Core Operating Limits Report

LaSalle County Station

Unit 1, Reload 4 (Cycle 5)

ISSUANCE OF CHANGES SUMMARY

Figure 2.2-1

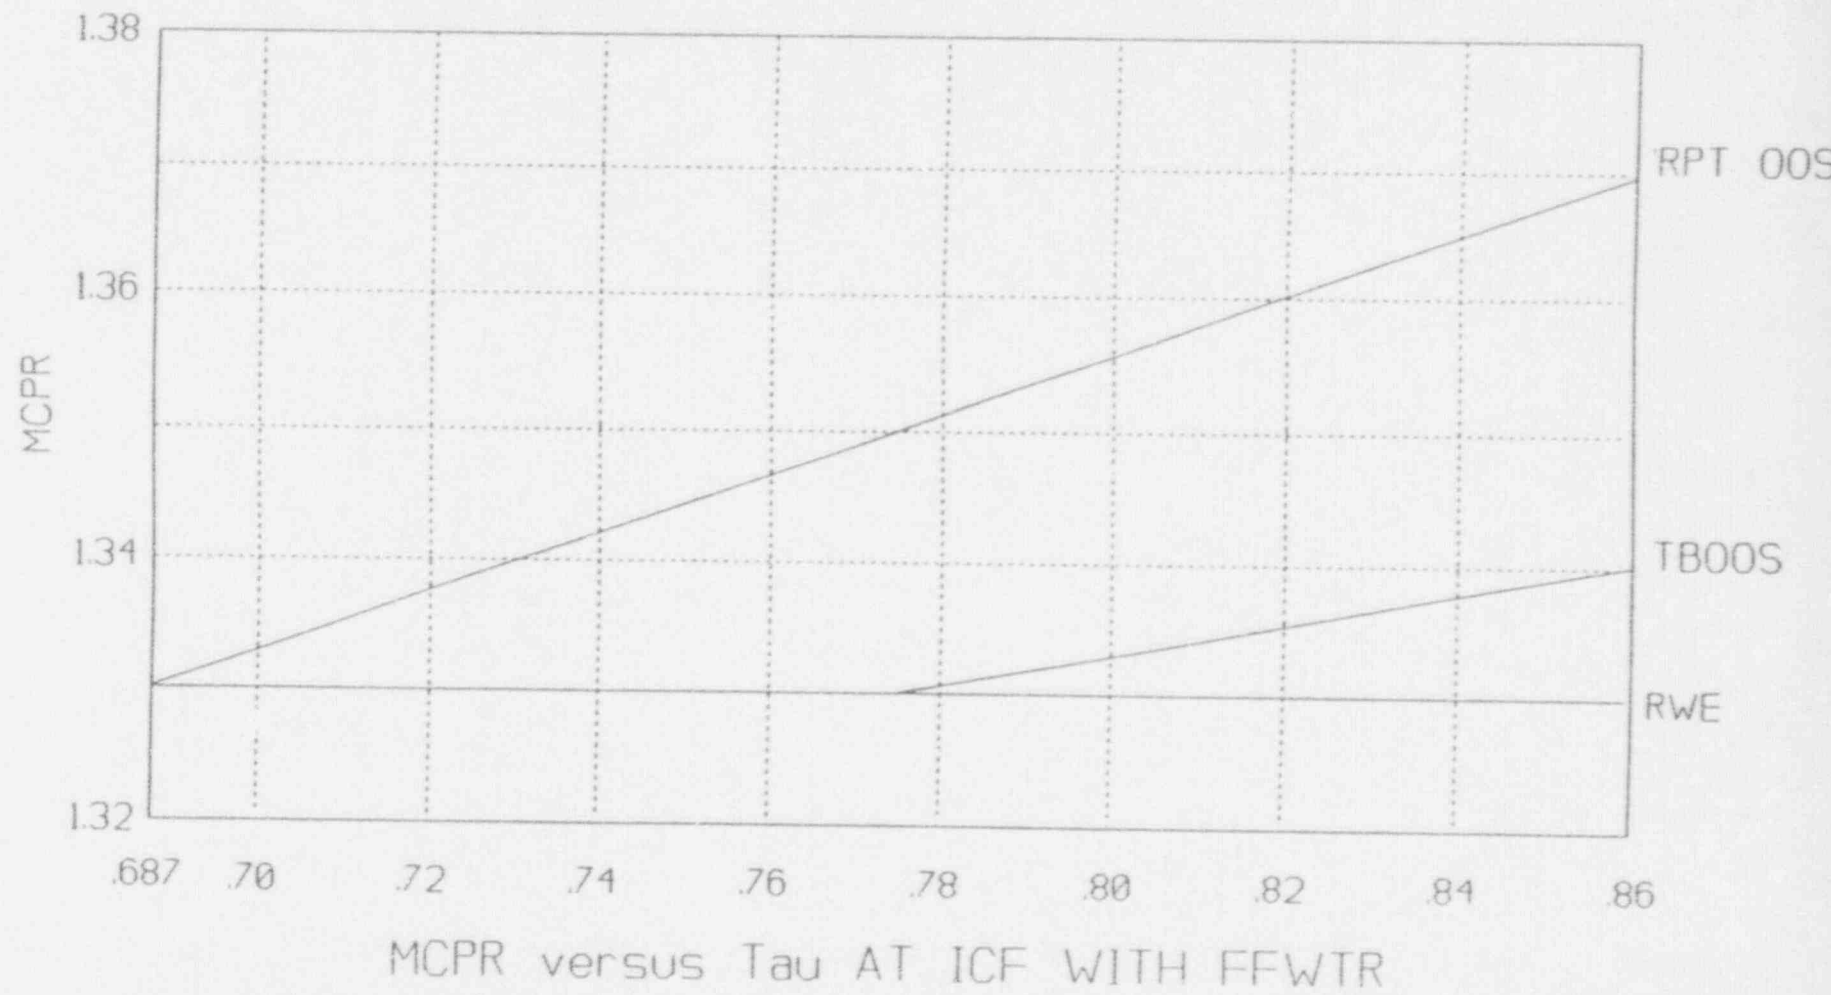
Affected Section	Affected Pages	Summary of Changes	Date
All	All	Original Issue (Cycle 4)	12/89
All	All	Original Issue (Cycle 5)	4/91
References	iii	References for new EOOS Analysis	3/92
List of	iv	Revised Title/Description for New	3/92
Figures		EOOS Analysis	
2.0	2-2	Revised MCPR Power Distribution	3/92
		Limits (all fuel types) for New	
		EOOS Analysis

The MCPR limit when in Single Recirculation Loop Operation is determined from Figure 2.2-1 plus 0.01, times the Kf factor determined from Figure 2.2-2.

The MCPR limit when in Dual Recirculation Loop Operation is determined from Figure 2.2-1 times the Kf factor determined from Figure 2.2-2.

The MCPR limit when in Dual Recirculation Loop Operation with the Main Turbine Bypass Inoperable (per Tech Spec 3.7.10) is determined from Figure 2.2-1 times the Kf factor determined from Figure 2.2-2.

The MCPR limit when in Dual Recirculation Loop Operation with the End-of-Cycle Recirculation Pump Trip System (RPT) Inoperable (per Tech Spec 3.3.4.2) is determined from Figure 2.2-1 times the Kf factor determined from Figure 2.2-2.
